# Work Order ID 77752

Item Name: Crosstube Turning Detail

DRAWING NO. D212-664-141	TITLE XTUBE ASSY (205/212/412 HI FWD)	REV. D	DART AEROSPACE LTD ENGINEERING ORDER		D.E.O. NO. D212-664-141-D-1	SHEET NO. SHEET 1 OF 2	SCALE NTS
DRAWN	CHECKED	MFG. APPR.	APPROVED	DE APPR.			
DATE 11.04.07	DATE 11.09.11	DATE 11.04.12	DATE 11/09/12	DATE 11.04.12

DRAWING NO. D212-664-141	TITLE CROSSTUBE ASS'Y (205 HI FWD)	REV. D	DART AEROSPACE LTD ENGINEERING ORDER		D.E.O. NO. D212-664-141-D-2	SHEET NO. SHEET 1 OF 1	SCALE NTS
DRAWN <i>UP</i>	CHECKED <i>ASS</i>	MFG. APPR. <i>AB</i>	APPROVED <i>MD</i>		DE APPR. <i>TH</i>		
DATE 11.07.15	DATE 11.07.20	DATE 11.07.21	DATE 11/07/21		DATE 11.07.21

**D212-664-141/-141B  
ASSEMBLY DETAIL**

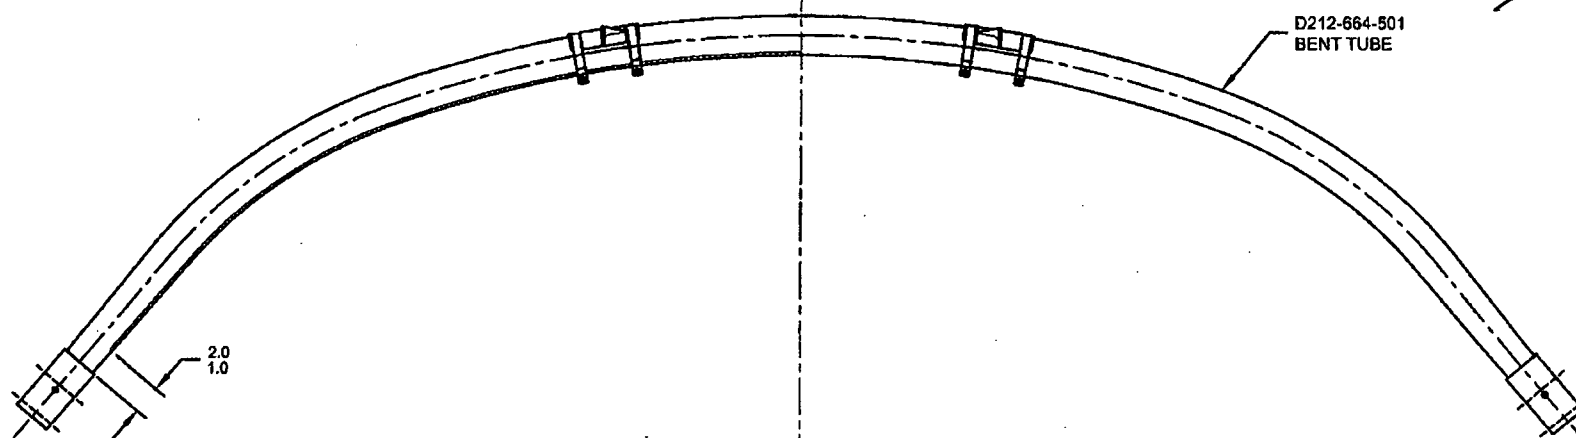
**PURPOSE:**

ADD AN INSPECTION WINDOW TO UNDERSIDE OF CROSSTUBE.

**CHANGE:**

NOTES 2 OF SHEET 1 IS AMENDED AS FOLLOWS:

**IS:**

- 2) FINISH: CHEMICAL CONVERSION COAT PER DART QSI 005 4.1  
PRIME INSIDE AND OUTSIDE PER DART QSI 005 4.2  
MASK UNDERSIDE OF CROSSTUBE AS SHOWN (HATCHED AREA) AND  
PAINT OUTSIDE PER DART QSI 005 4.2  
REMOVE MASKING AND APPLY CLEAR COAT

MASK AREA PRIOR TO PAINTING.  
REMOVE MASKING AFTER PAINT  
AND APPLY CLEAR COAT
